The Great Grid Upgrade

Norwich to Tilbury

2023 Non-Statutory Consultation Feedback Report

AENC-NG-CNS-REP-0007

Figure 4.18- South Norfolk section map

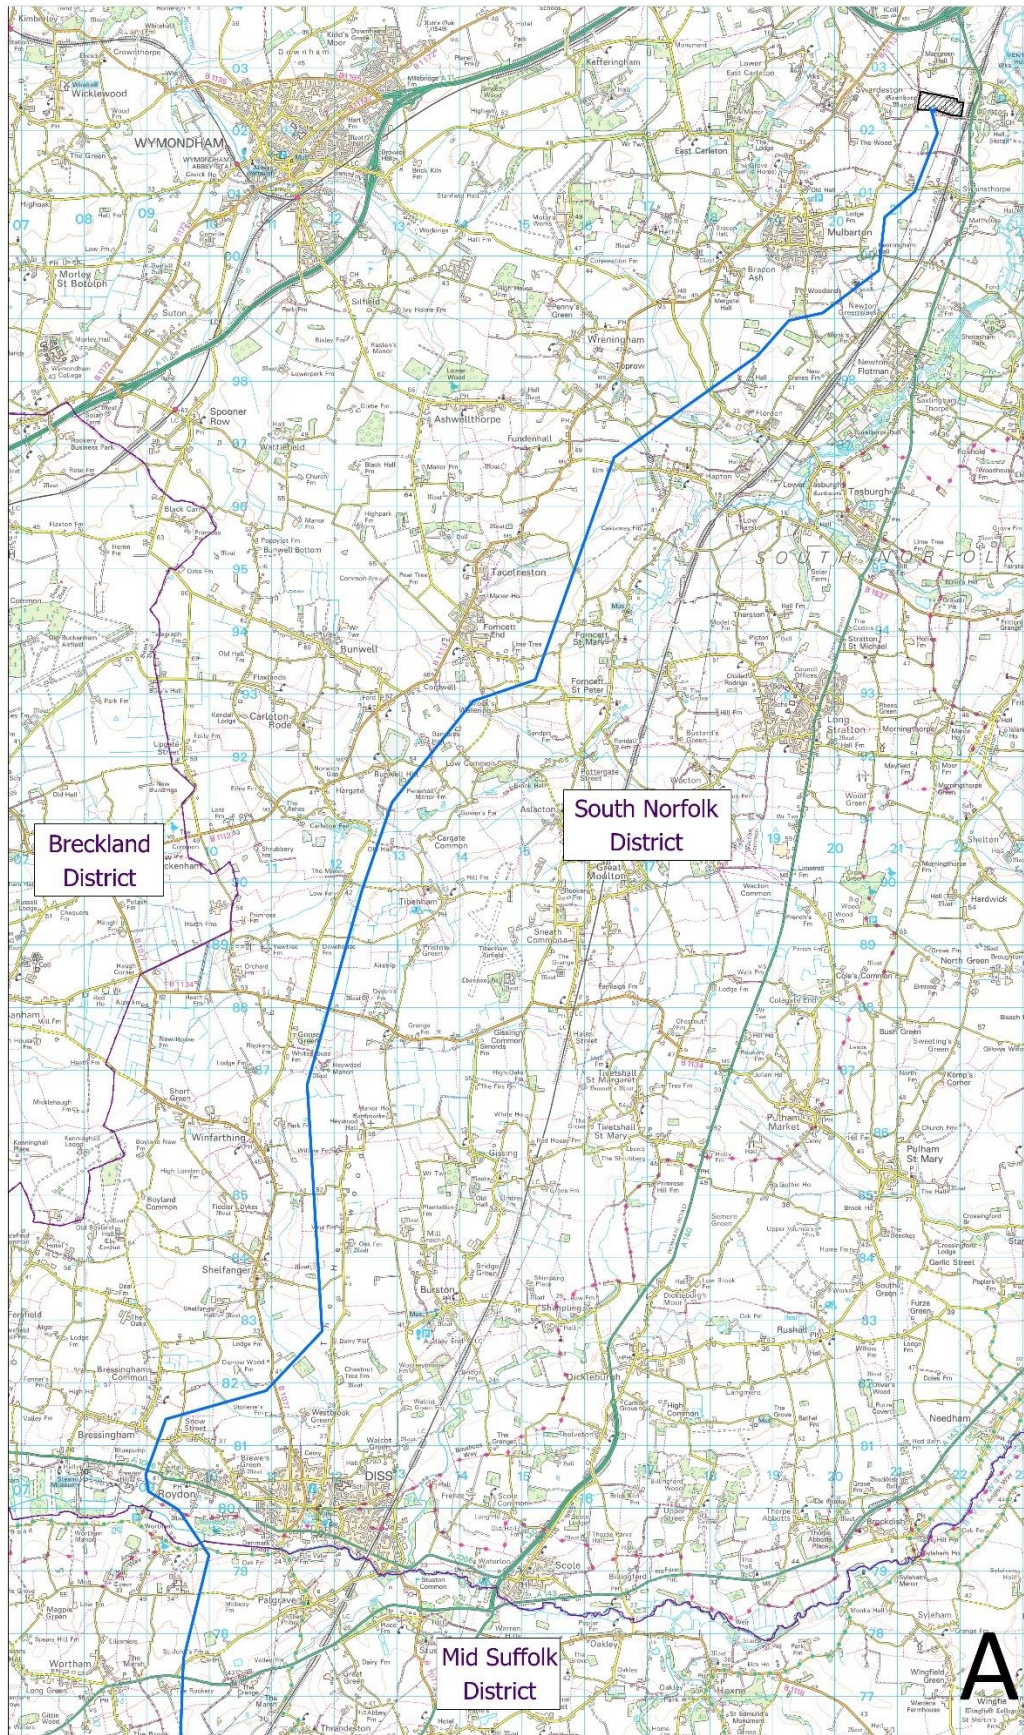
Ref no.	Summary of matters raised	National Grid's response
Agricultural Land		
4.11.1	Concern that the Project will take away valuable agricultural land / disrupt farming operations.	National Grid is and will continue to work with all landowners including farmers who may be affected by the proposals to understand the impacts on their operations and to work with them as the Project is developed. We will seek to work with the farming community to limit disruption where practicable. This includes providing prior warning of works which may result in the need to move livestock. Compensation claims for disturbance are considered on a case-by-case basis, if negative impact on farming operations can be proven. Particular agricultural matters can also be addressed through voluntary land agreements.

Figure 4.19- Mid Suffolk section map

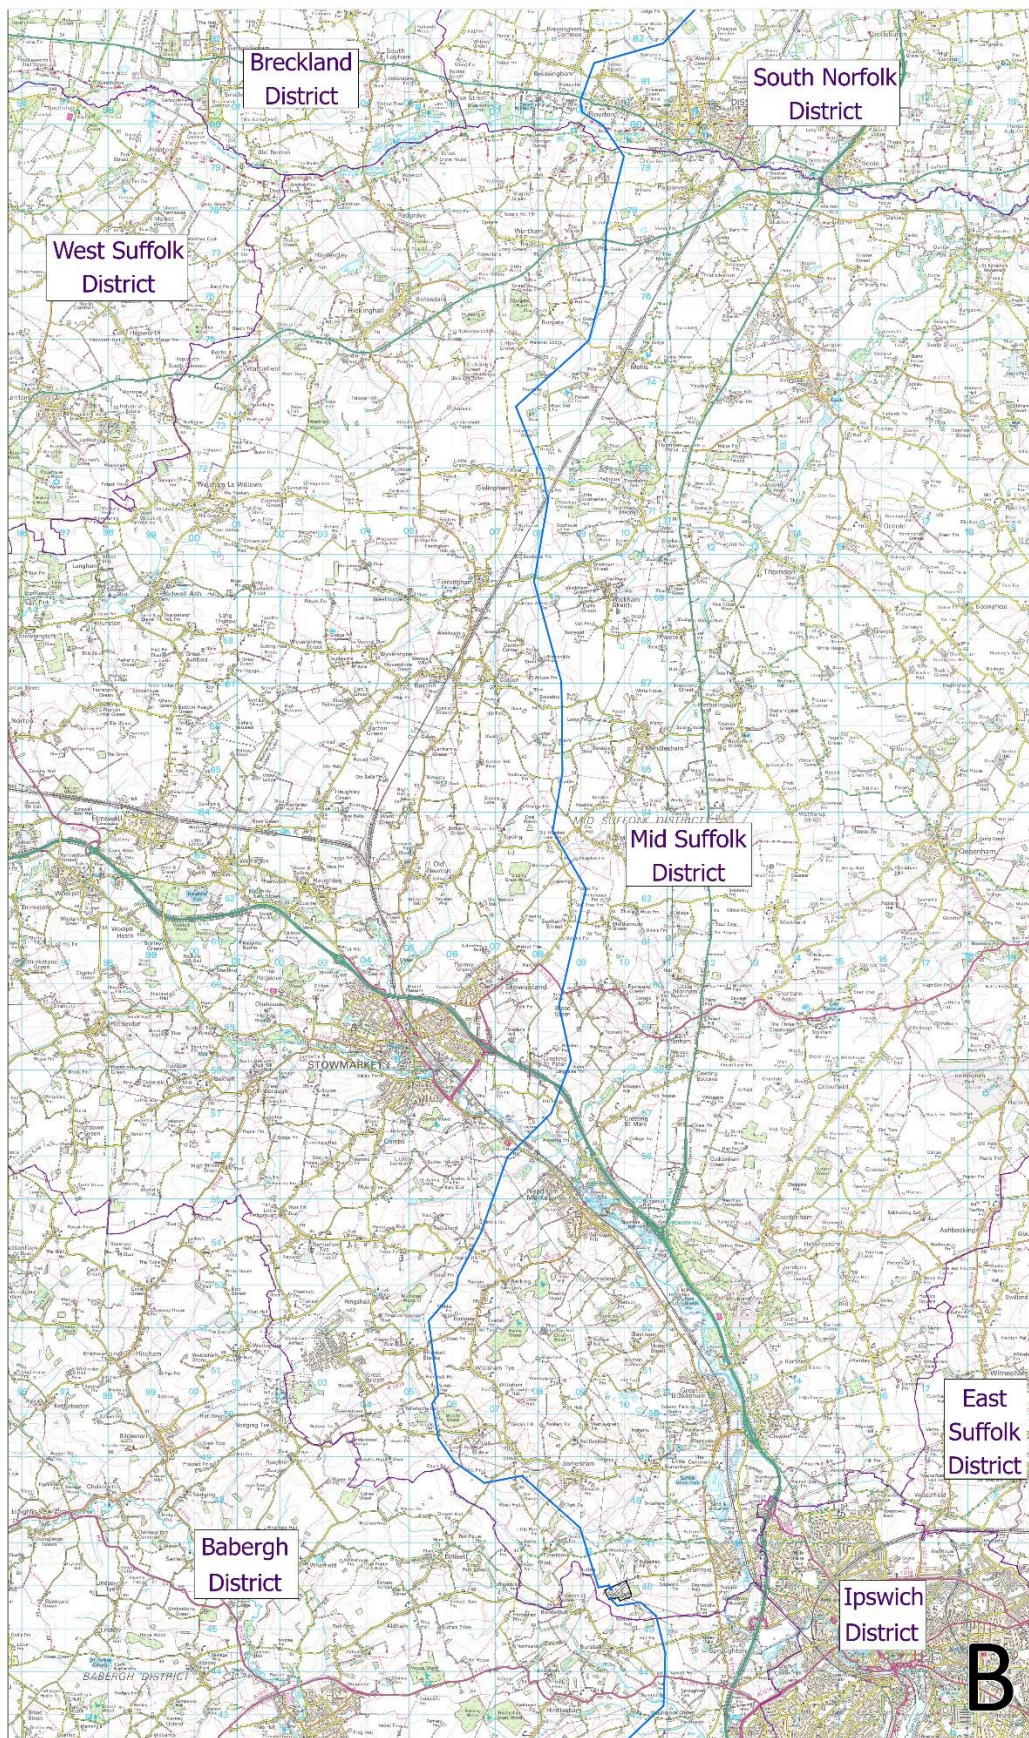
Ref no.	Summary of matters raised	National Grid's response
Agricultural Land		
4.12.1	Concern that the Project will take away valuable agricultural land / disrupt farming operations.	National Grid is and will continue to work with all landowners including farmers who may be affected by the proposals to understand the impacts on their operations and to work with them as the Project is developed. We will seek to work with the farming community to limit disruption where practicable. This includes providing prior warning of works which may result in the need to move livestock. Compensation claims for disturbance are considered on a case-by-case basis if negative impact on farming operations can be proven. Particular agricultural matters can also be addressed through voluntary land agreements.

Figure 4.20- Babergh, Tendring and Colchester section map

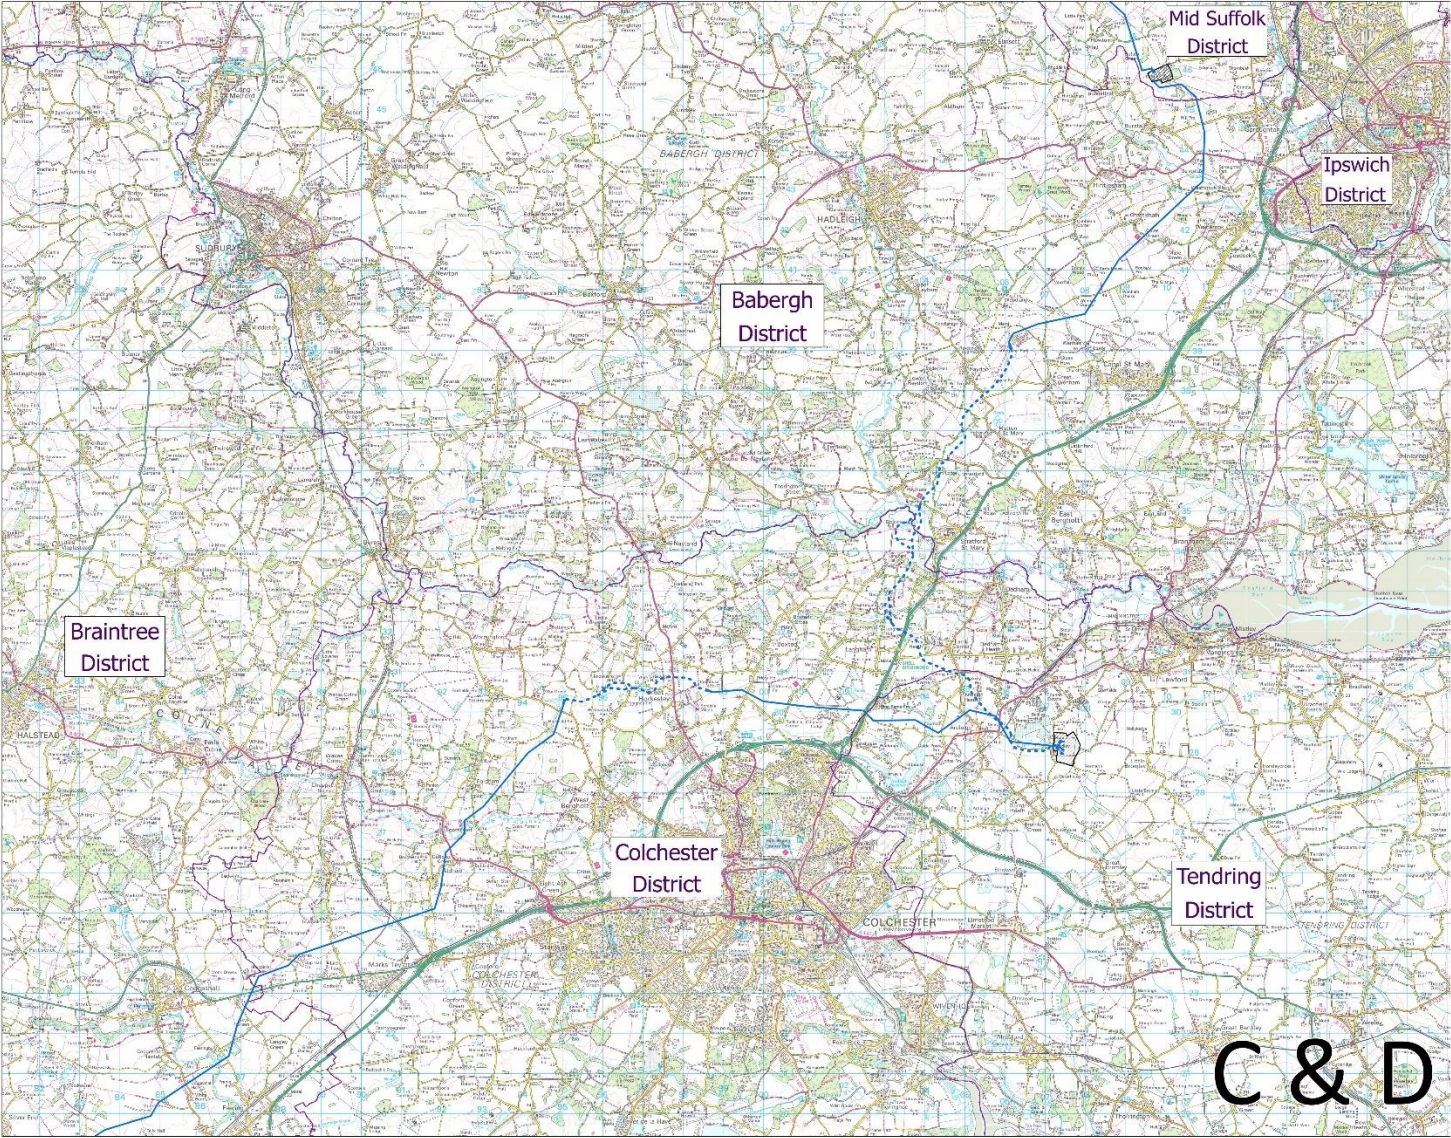
Ref no.	Summary of matters raised	National Grid's response
Agricultural Land		
4.13.1	Concern that the East Anglia Connection Node (EACN) substation will destroy productive farmland (i.e., contradictory to the UK ambition to grow more food, and pollution resulting in the need to transport food from abroad).	Siting of the East Anglia Connection Node (EACN) substation takes into account a wide range of factors and must arrive at a balanced position, in particular weighing the effects from the two overhead lines required to transmit the power from the site. National Grid will continue to work with all landowners, including farmers who may be affected by the proposals, to understand the impacts on their operations and to work with them as the Project develops. We will seek to work with the farming community to limit disruption where practicable. Where land is required for new permanent apparatus, we will look to acquire the minimum area required.

Figure 4.21- Braintree section map

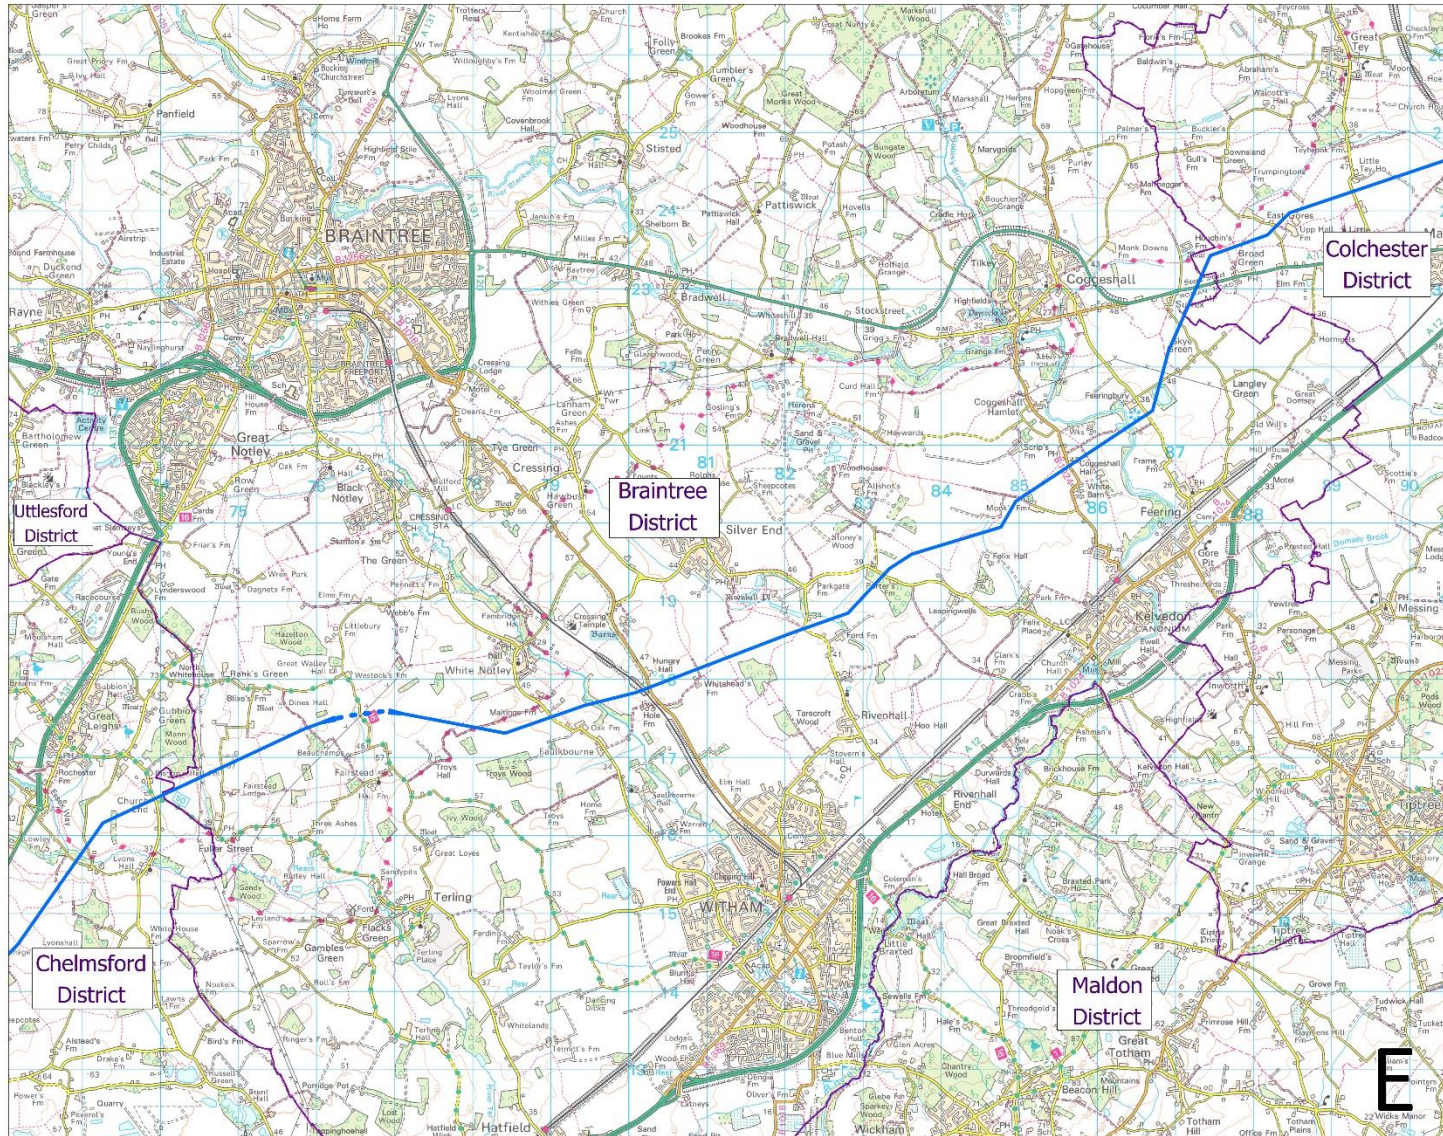
Ref no.	Summary of matters raised	National Grid's response
Agricultural Land		
4.14.1	Concern that the Project will take away valuable agricultural land / disrupt farming operations.	National Grid is and will continue to work with all landowners including farmers who may be affected by the proposals to understand the impacts on their operations and to work with them as the Project is developed. We will seek to work with the farming community to limit disruption where practicable. This includes providing prior warning of works which may result in the need to move livestock. Compensation claims for disturbance are considered on a case-by-case basis, if negative impact on farming operations can be proven. Particular agricultural matters can also be addressed through voluntary land agreements.

Figure 4.22- Chelmsford section map

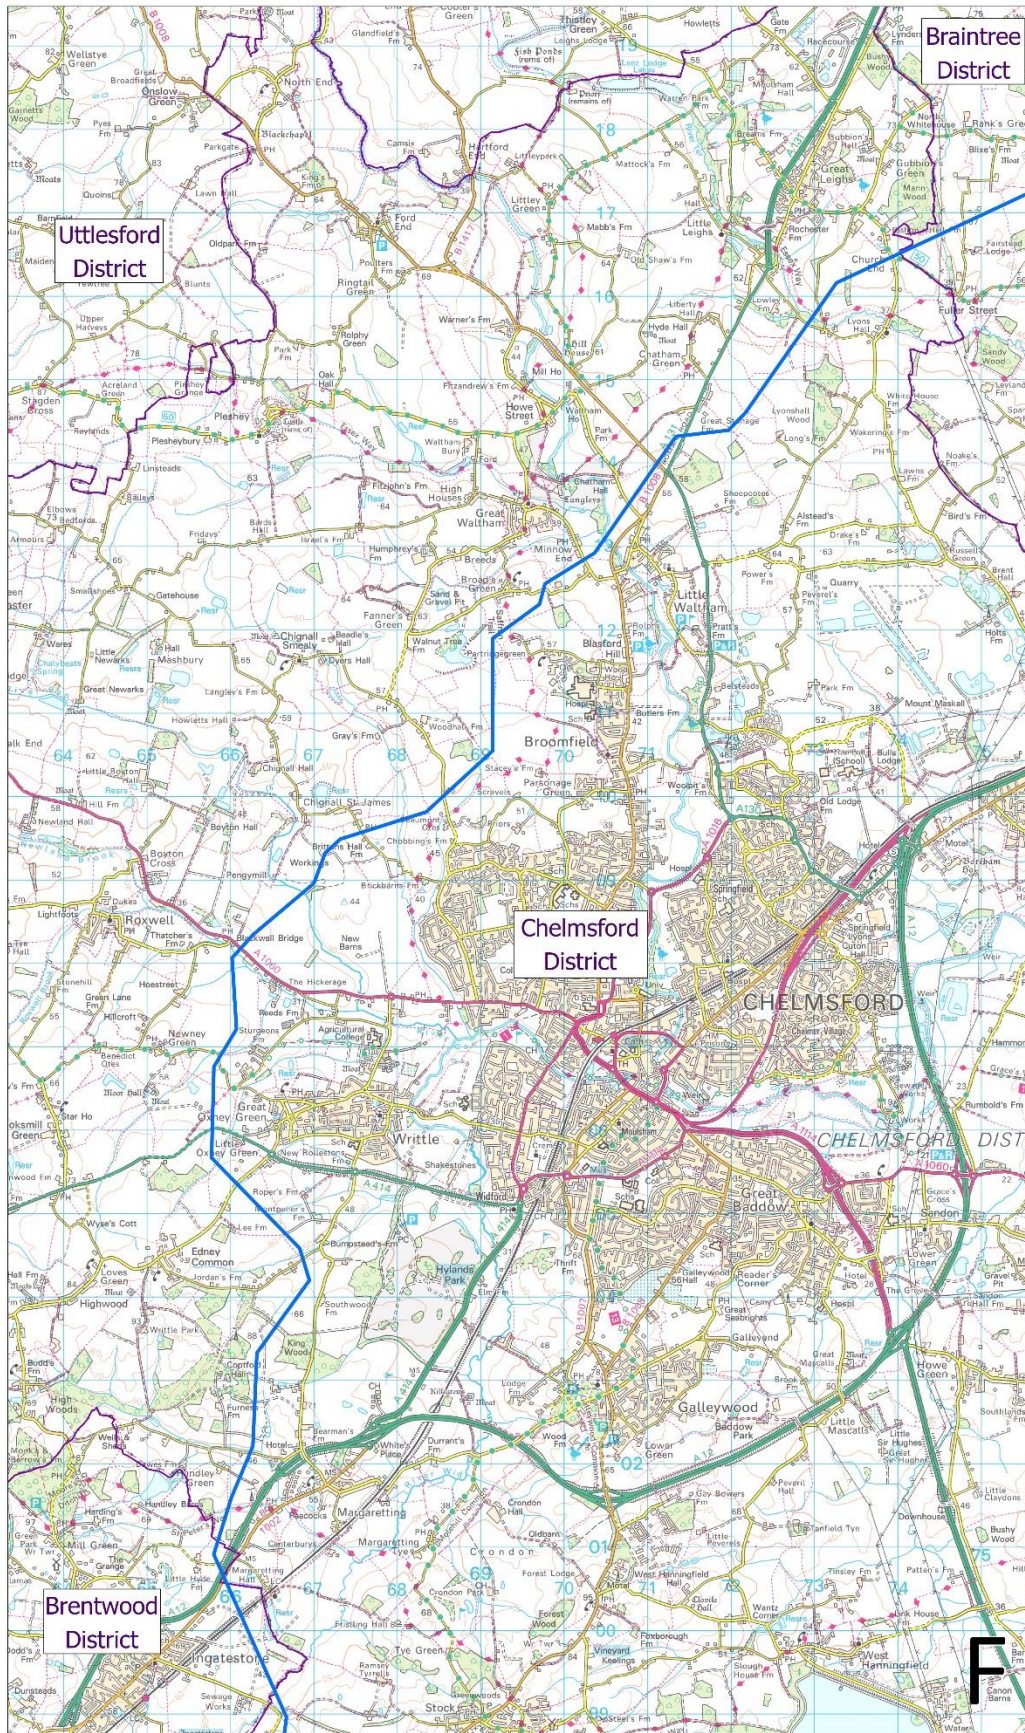
Ref no.	Summary of matters raised	National Grid's response
Agricultural Land		
4.15.1	Concern about the impact of concrete haul roads on farming (e.g., concern over the loss of farming/ grazing land due to setting of concrete haul roads (for up to 3 years) around pylon sites / Concern on the long term impacts of concrete haul roads on soil structure and drainage in farming fields (fields that are tile drained)).	National Grid is currently in the process of determining where haul roads and work areas will be required, including determining the methodology on how these will be installed, materials used and the duration they will remain in place. There may be temporary impacts on agricultural drainage systems, and this will need to be mitigated through installing temporary drainage systems and reinstatement of existing drainage on the completion of the works. Soil management will be in place when stripping and storing soil to ensure that reinstatement can be successful and restore the land to its original condition.
